K19071 I-5 Rose Quarter Improvement Project Administrative Public SEA

City of Portland Review Log

RE: ODOT I-5 Rose Quarter Supplemental Environmental Assessment

Subject: I-5 Rose Quarter Supplemental Environmental Assessment (SEA) comments

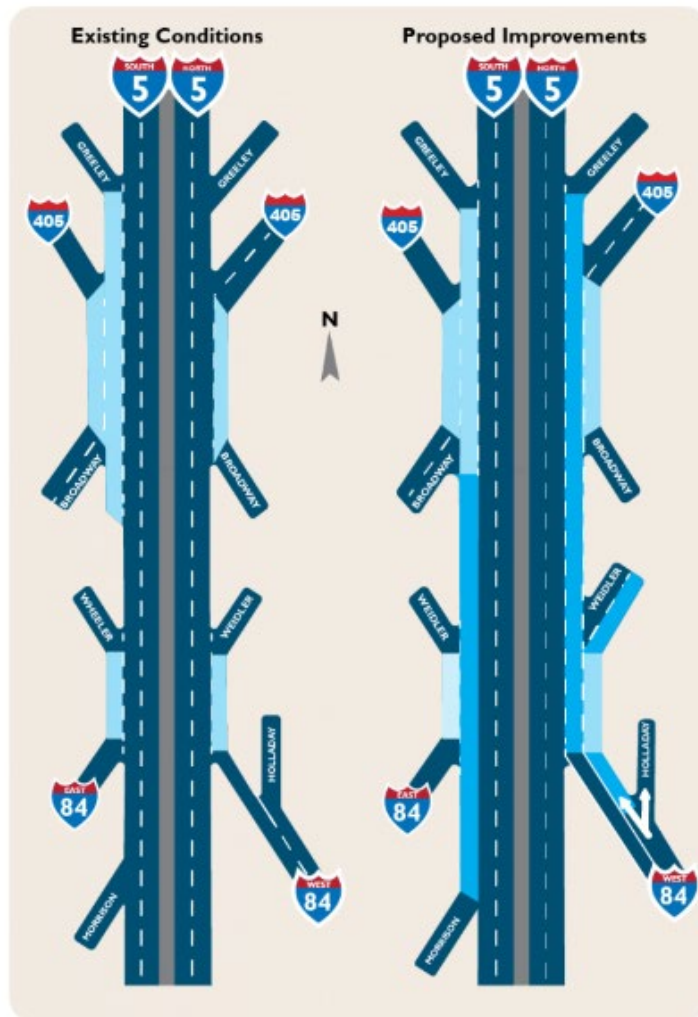
The Green Loop is planned to be the premier bicycle route in Portland, but it will lose its luster without the safety and comfort provided by the formerly proposed Clackamas Bridge. In addition to providing restorative justice, another intent of the City of Portland is to provide a high quality bicycle facilities and park-like experience on the Green Loop. Removing the Clackamas bridge is in direct contradiction with Portland 2035 Central City recommendation for a connection over the I-5. The bridge must remain, and the approach path must be realigned toward NE Multnomah Street until it can cross the I-5. Perhaps the overhead ODOT sign bridge between exit 302a and 301 (45.53199691950909, -122.66535046490218) can be replaced with a walking/bicycling bridge and the ODOT signs reattached (Option 1). After crossing I-5, the bridge can then return to NE Ramsay Way along the curvature of N Wheeler Ave.

Above is a conceptual idea of two options that we ask the design team to explore. There appears to be room in the polygon between Williams off ramps and Wheeler on ramps to explore option 2. In this city-designated bicycle district the 2030 Bicycle Master Plan section 2.3.1 states that “within certain dense, mixed-use areas of Portland with multiple destinations along most streets, all streets need to function well for people bicycling to or through the district.” Additional clarification is provided in section 2.3.5 on page 29, “[a]s focal points for economic, recreational and employment activities, such areas need to be exceptionally welcoming to people arriving by and traveling through by bicycle.” Clackamas bridge could provide a safer connection to Flint Avenue to further “recognize the important role of Flint Avenue as a community-oriented connection between the Rose Quarter and Lillis Albina Park.” To add even greater emphasis on bicycling and walking in the area, the installation of a bridge should not preclude the installation of a cycle track along Weidler. Nevertheless, Weidler is not a suitable or welcoming multi-use path compared to the Green Loop/Clackamas plan previously approved in the Central City 2035 Plan. A bridge, preferably an attractive one like Blumenauer, would be especially welcoming. The Revised Build

OREGON DEPARTMENT OF TRANSPORTATION'S DIAGRAM SHOWING THE NEED FOR ADDITIONAL "AUXILIARY" LANES ON I-5. (ODOT)

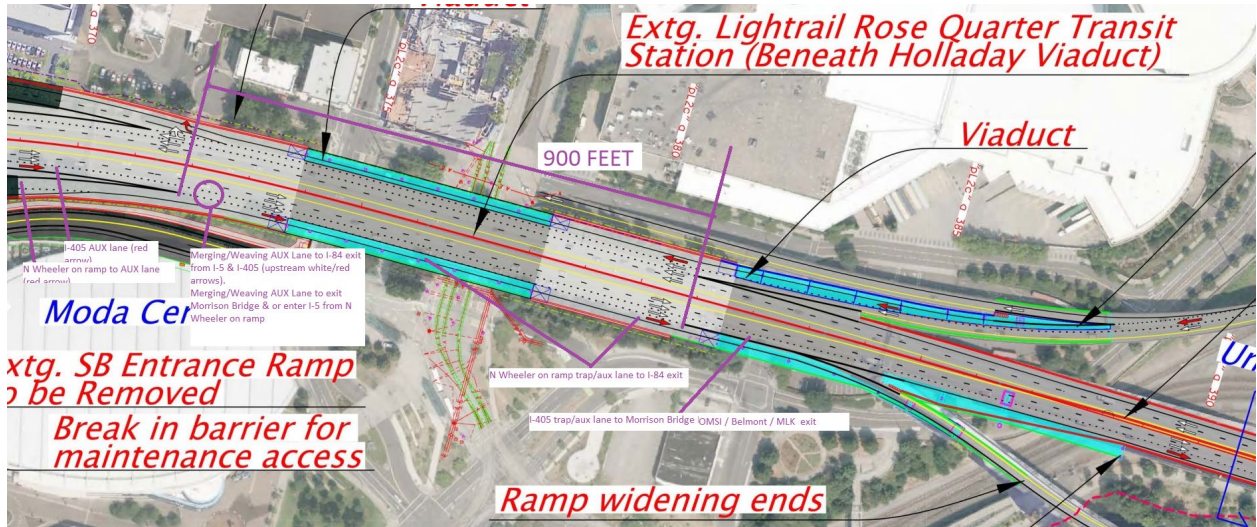
In the figure above, we see that I-5 users will have to change lanes twice to exit at Broadway or I-84, first weaving to their right across the Morrison Bridge auxiliary lane and then changing lanes into the Greeley auxiliary lane to I-84 exit. I-5 users wishing to exit at Morrison Bridge will have to decide when to weave and change lanes, at Greeley, at 405, or after I-84 to take the Morrison bridge exit. A similar hazard will be present for northbound traffic. I-5 users will now have to change lanes twice to exit at Weidler or I-405, first weaving to their right across the I-405 auxiliary lane and then changing lanes into the I-84 auxiliary lane to Weidler exit. Northbound I-5 users wishing to exit at Greeley will have to decide when to weave and change lanes at I-84, at Weidler, or after I-405 to take the Greeley Ave exit. In the figure below we see that much of this lane changing and weaving of I-405, I-84, and I-5 will take place across three lanes in just 900 feet. There is research that shows "crash frequency is positively proportional to the number of lanes

on the freeway and the average daily traffic per lane on the freeway, but **negatively proportional to the length of the auxiliary lane and the percentage of heavy vehicles on the freeway.**"²

Another study found that “if the weaving segment is followed by an entrance/exit ramp and this ramp has high traffic volume, it can be less operationally favorable to extend and terminate the auxiliary lane at this entrance/exit ramp location. Instead, dropping the auxiliary lane before this entrance/exit ramp represents a more operationally effective option.”³

A third study finds: that for an auxiliary lane diverging and merging from outside, the optimum length should be “1,000m – 1,500m and be added from around the start of vertical curve to several hundred meters beyond the end of vertical curve.”⁴ 1000m is 3280 feet, not 900’.
